DESCRIPTION AND SAFETY ANALYSIS
OF PROPOSED CHANGE NPF-10/15-224 (REV. 4)

This is a request to revise Technical Specification 3/4.7.1.5, "Main Steam Line Isolation Valves," and Technical Specification 3/4.7.1.2, "Auxiliary Feedwater System."

DESCRIPTION AND SAFETY ANALYSIS
OF PROPOSED CHANGE NPF-10/15-231

This is a request to revise Technical Specification 3/4.1.3.6. "Regulating CEA Insertion Limits."

FIGURE 3.1-2

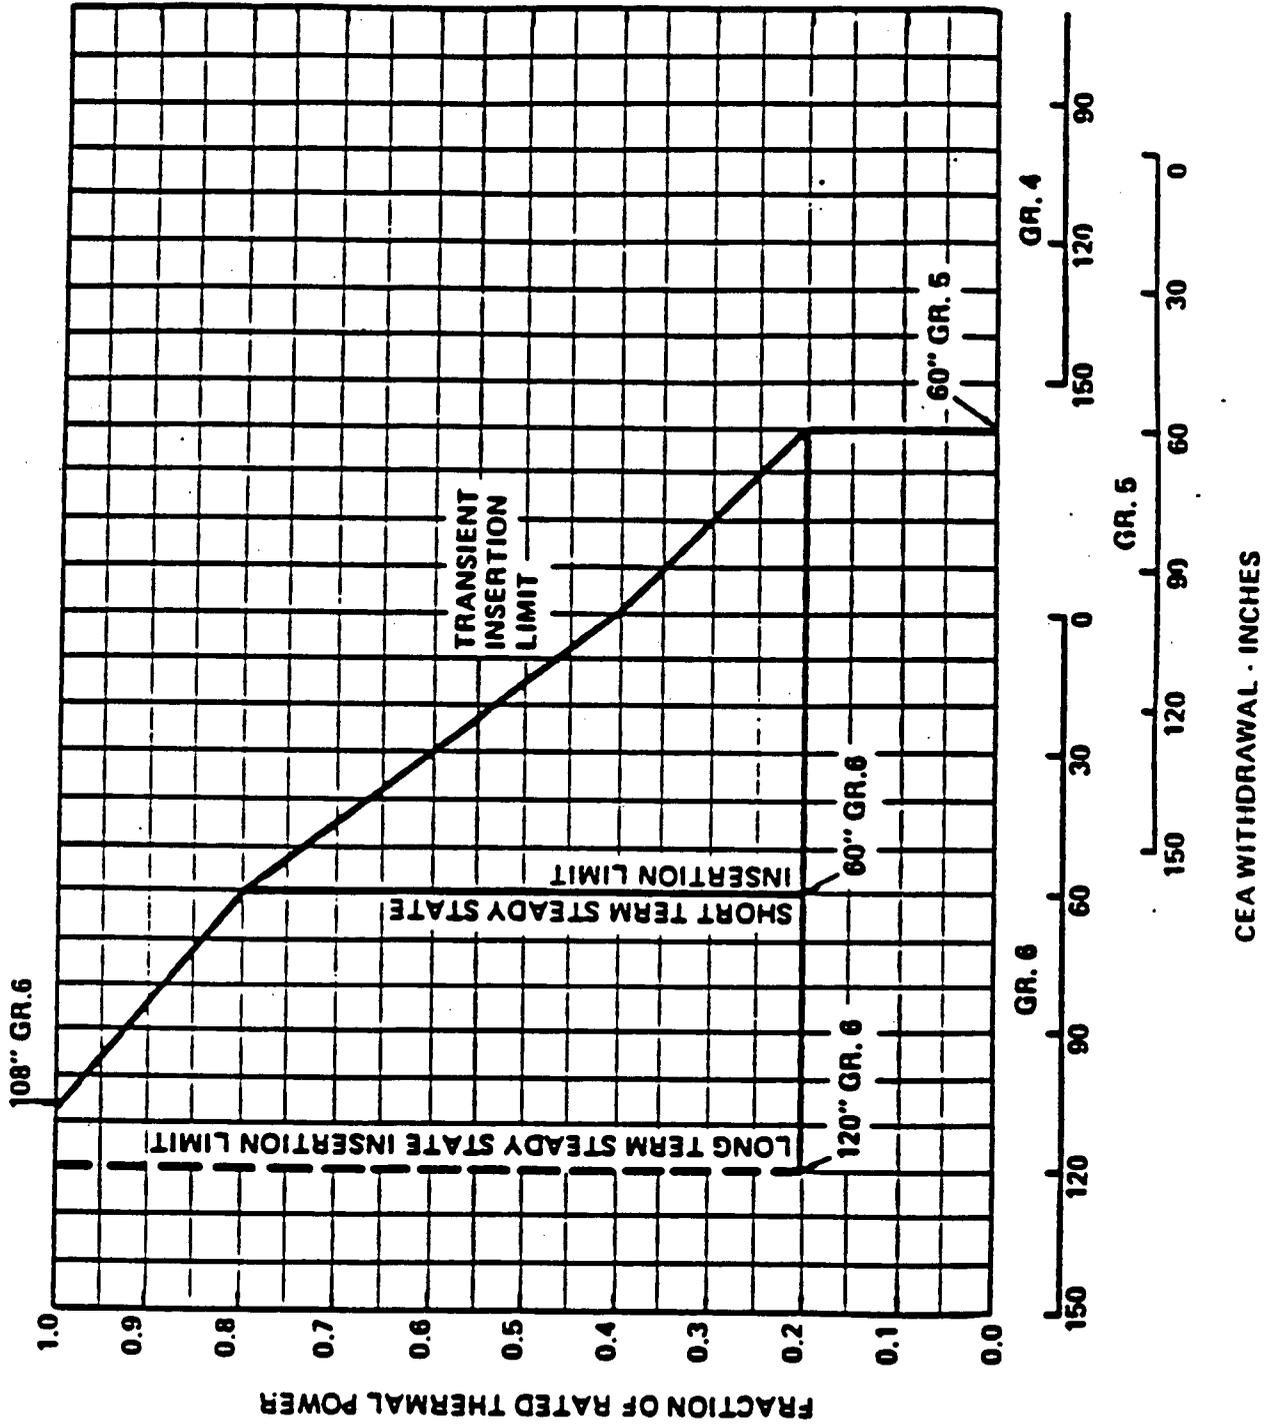
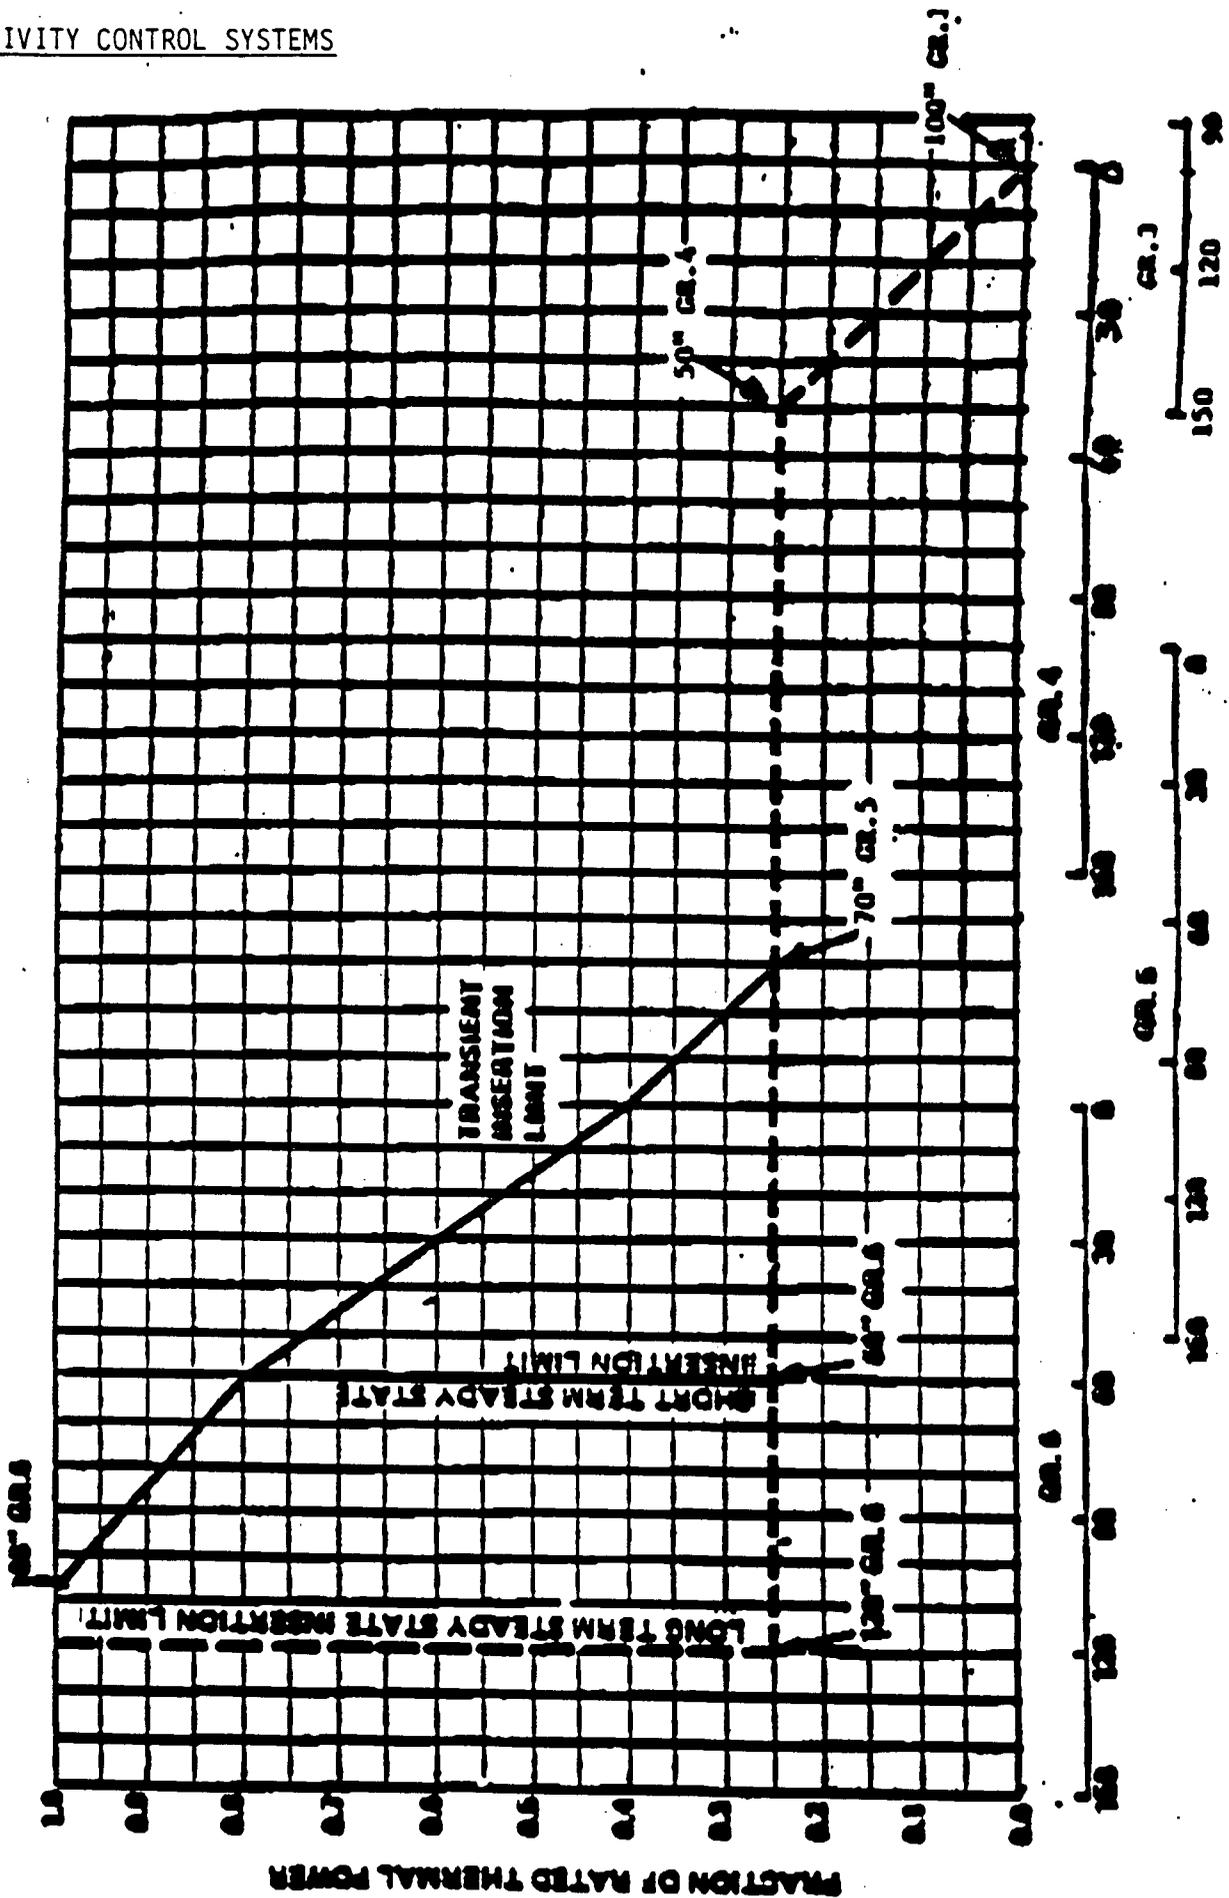
The proposed change revises Figure 3.1-2 of Technical Specification 3/4.1.3.6, "Regulating CEA Insertion Limits." The existing Technical Specification Figure 3.1-2 provides the CEA withdrawal sequence and insertion limits when the Core Operating Limit Supervisory System (COLSS) is in or out of service. The figure also delineates the Short Term and Long Term Steady State Insertion Limits.

The revised Technical Specification figure relaxes the CEA insertion limits at low power levels (at or below 25% power). Relaxation of the Power Dependent CEA Insertion Limits (PDIL) at low power levels will increase flexibility in the determination of Estimated Critical Position (ECP) during plant approach to criticality and will also help reduce the amount of waste water generated during a plant start up. With the current limits, boration may be required before a start up in order to assure that the ECP is within the zero power CEA insertion limits. Less restrictive CEA insertion limits will preclude the need to borate prior to startup thus reducing the volume of waste water.

FIGURE 3.1-2

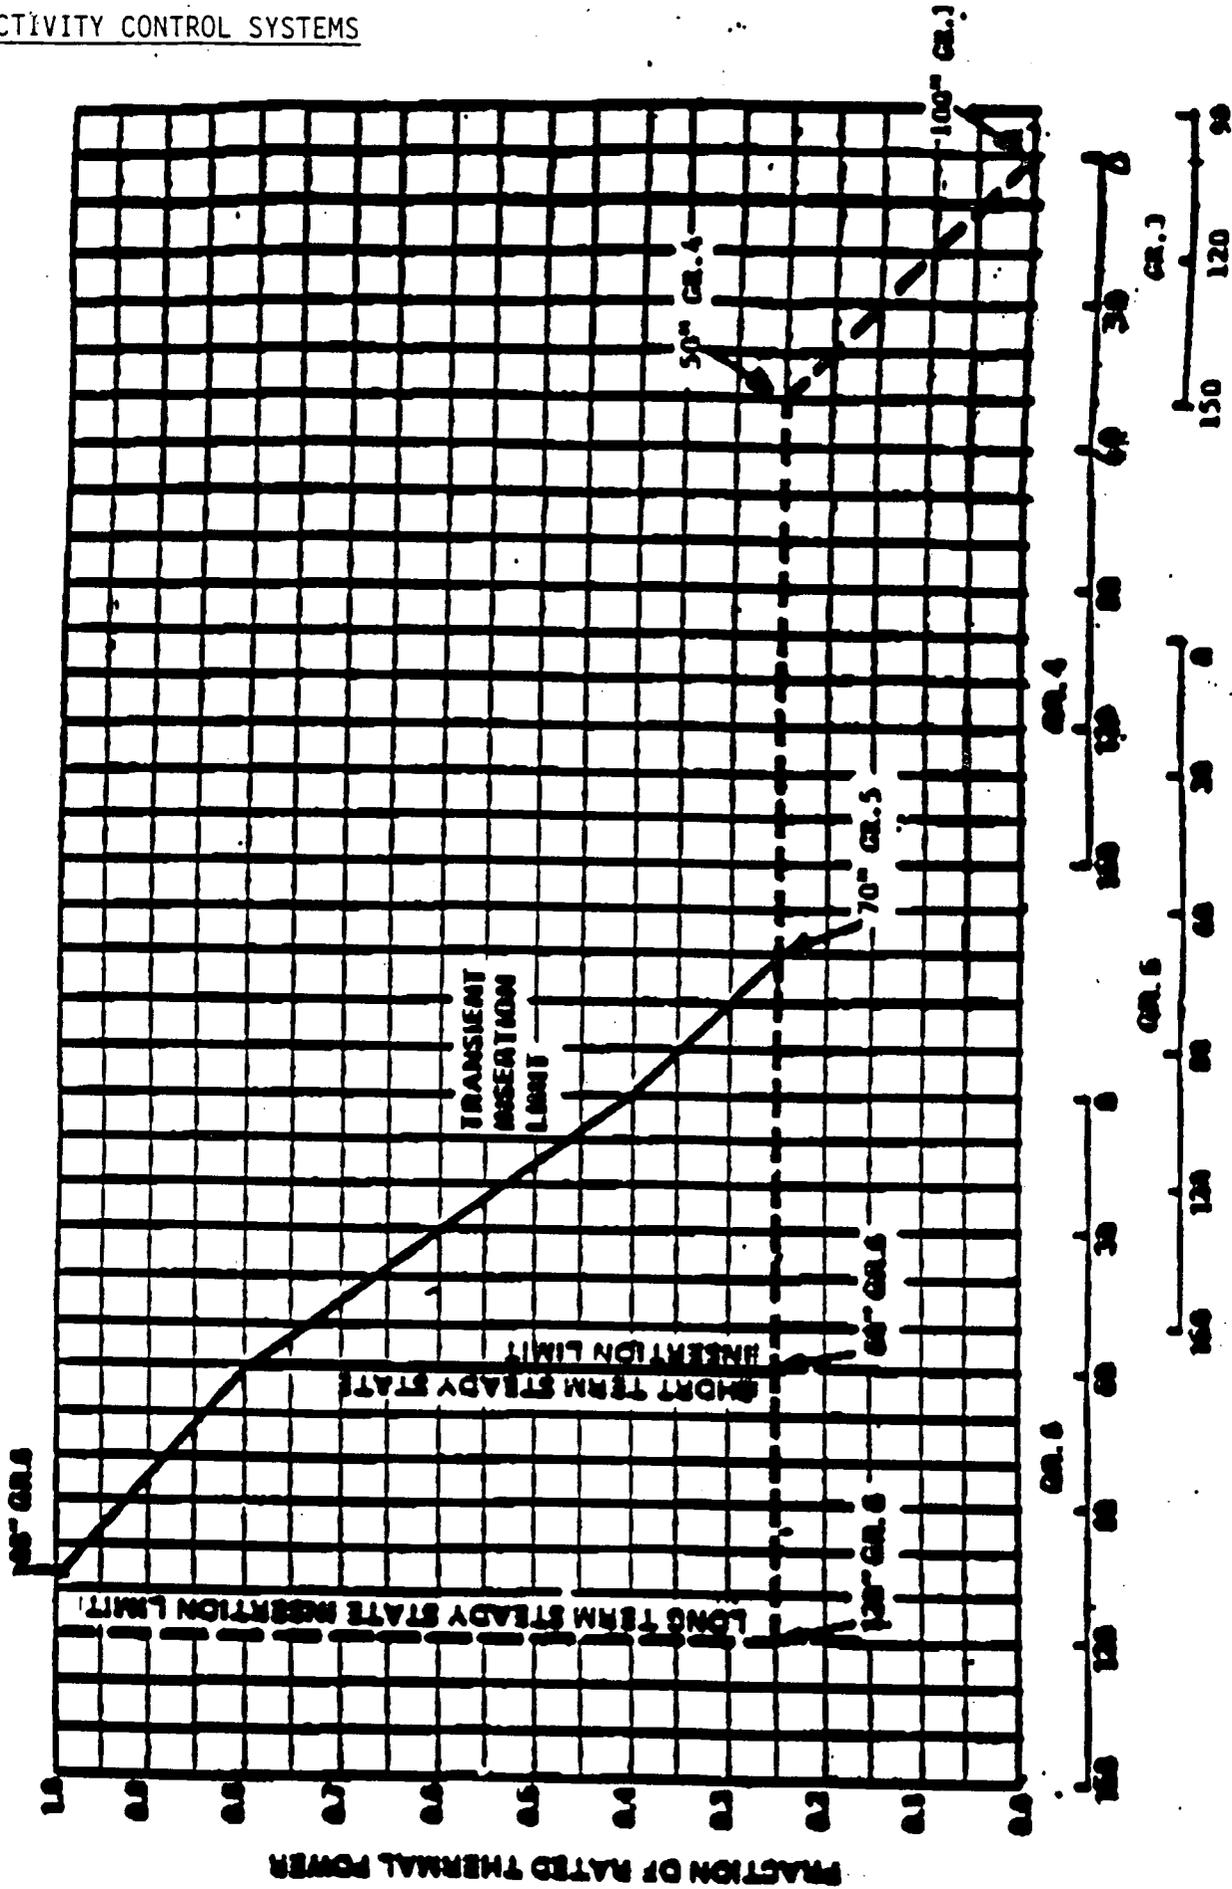
The proposed change revises Figure 3.1-2 of Technical Specification 3/4.1.3.6, "Regulating CEA Insertion Limits." The existing Technical Specification Figure 3.1-2 provides the CEA withdrawal sequence and insertion limits when the Core Operating Limit Supervisory System (COLSS) is in or out of service. The figure also delineates the Short Term and Long Term Steady State Insertion Limits.
